Access Compliance Report

Public Rights-of-Way

(Curb Ramps)

Intersection ID: 30513	Main Street: S_TRYON_ST	Cross Street: YORK_CENTER_DR	Location: NE
ADA ID: F142142EE3C3	Ramp Type: PerpDiag	Initial Pass/Fail: Fail	Overall Compliance: No
			Severity Score: 46.25

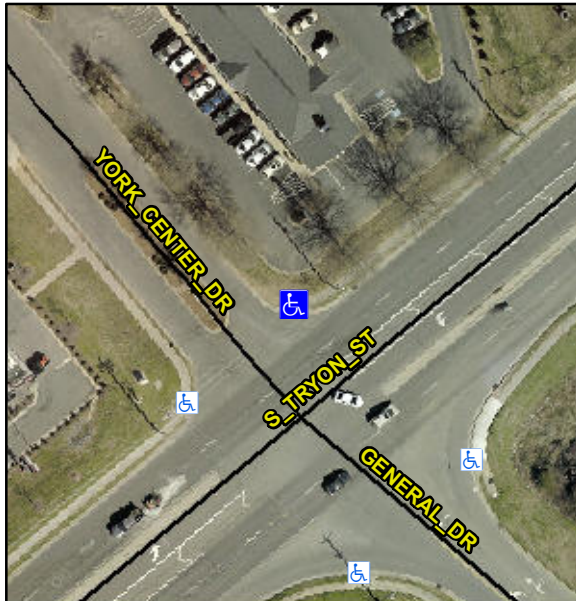
R304.5.1, R304.2.2, R304.5.3

Compliance	Description	Data	Compliance	Description	Data
N/A	Ramp Length (in)	48.0	No	Ramp Slope (%)	10.7
No	Ramp Width (in)	45.0	No	Ramp XSlope (%)	7.2
N/A	Flare Type LT	N/A	N/A	Flare Type RT	N/A
N/A	Flare Slope LT (%)	N/A	N/A	Flare Slope RT (%)	N/A
N/A	Flare Traversable LT?	N/A	N/A	Flare Traversable RT?	N/A
N/A	Landing Length (in)	N/A	N/A	DWS Provided?	N/A
N/A	Landing Width (in)	N/A	N/A	DWS Contrast?	N/A
N/A	Landing Slope (%)	N/A	N/A	DWS Length (in)	N/A
N/A	Landing X Slope (%)	N/A	N/A	DWS Full Width?	N/A
N/A	Landing Curb? (Y/N)	N/A	N/A	DWS Offset (in)	N/A
N/A	Shared Landing?	N/A			
N/A	Gutter Ponding?	N/A	N/A	Gutter Slope (%)	N/A
N/A	Gutter Lip Ht (in)	N/A	N/A	Gutter X Slope (%)	N/A
N/A	Painted X Walk1?	No	N/A	Painted X Walk2?	No
	X Walk 1 Direction	To SW		X Walk 2 Direction	To SE
N/A	X Walk 1 Width (in)	N/A	N/A	X Walk 2 Width (in)	N/A
	X Walk 1 Slope (%)	0.9		X Walk 2 Slope (%)	3.0
	X Walk 1 X Slope (%)	3.0		X Walk 2 X Slope (%)	1.8

Remove & Replace Curb Ramp With Two New Directional Ramps or Equivalent.
